Re: Proposed erection of a single new low energy and low carbon dwelling
Application number - P241412/F

Thank you for your email dated 06.09.2024 requesting further information. We can confirm the following:

IKOslate roof tile

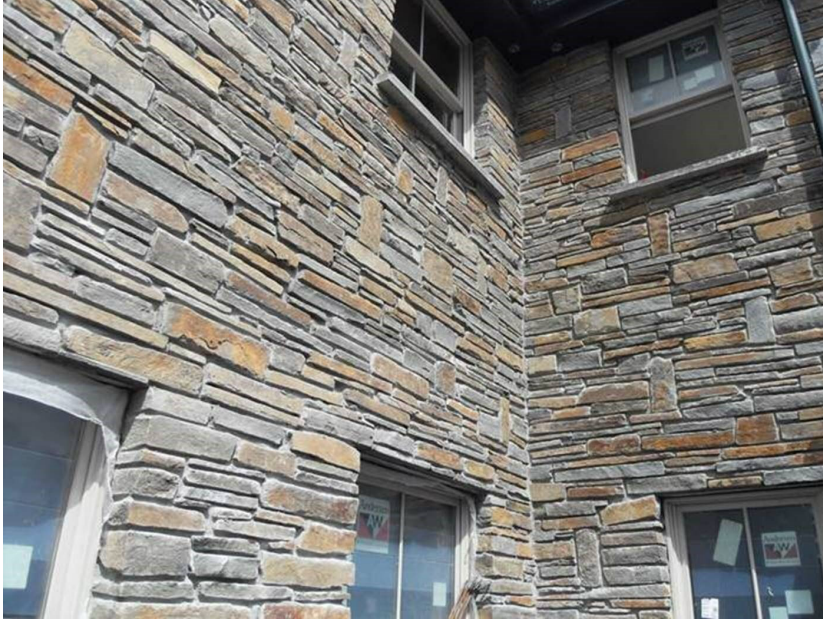
2.01 The roof - is proposed to be [IKOslate](#) a composite roof tile manufactured from mineral-reinforced, 99% recycled, and re-engineered materials (see below). It has the colour & appearance of natural grey/blue slate. PV panels will be matt finished & frameless.
